Product Change Notification (PCN)

PCN #: 12D-2021

DATE: 12/15/2021

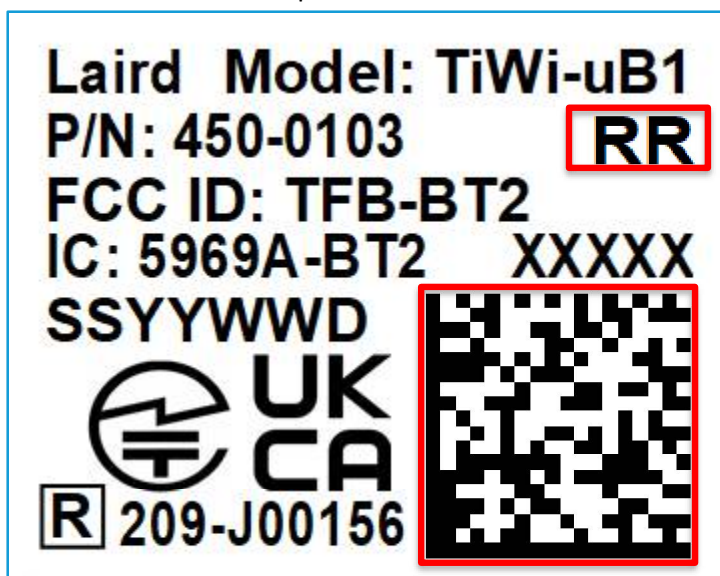
- UKCA Logo added to base module labels (Tape & Reel, Cut Tape, and Carton already have UKCA logo).
- Upper-level assemblies have been up rev'd due to this change.
- Company Naming Changed (LSR to Laird)
